CellComSL Series Alarm Communicators

January 2016

Hardware Update

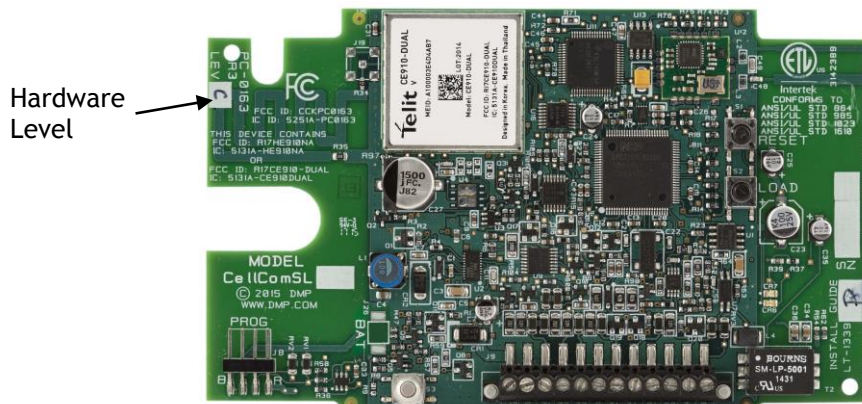
As of January 26, 2016 all CellComSL Series Universal Alarm Communicators are being manufactured and shipped with updated Level C Hardware.

The following issue only occurred with CellComSLC Series Communicators manufactured with PC-0163 Level B hardware. This issue does not occur on the previous CellcomSLC Series manufactured on PC-0159. See Technical Update TU-0829 released December 21, 2015.

When using Zone 3 as a zone input connection, the CellComSL with Level B hardware would always report the zone as open. This would occur even though the end of line resistor was in a normal condition.

To update a Level B CellComSLC to Level C hardware, return the CellComSLC to DMP and simply indicate "Update to Latest Revision" on the RMA tag. This update will be provided at no charge. If you need RMA tags, contact DMP Customer Service at 1-800-641-4282.
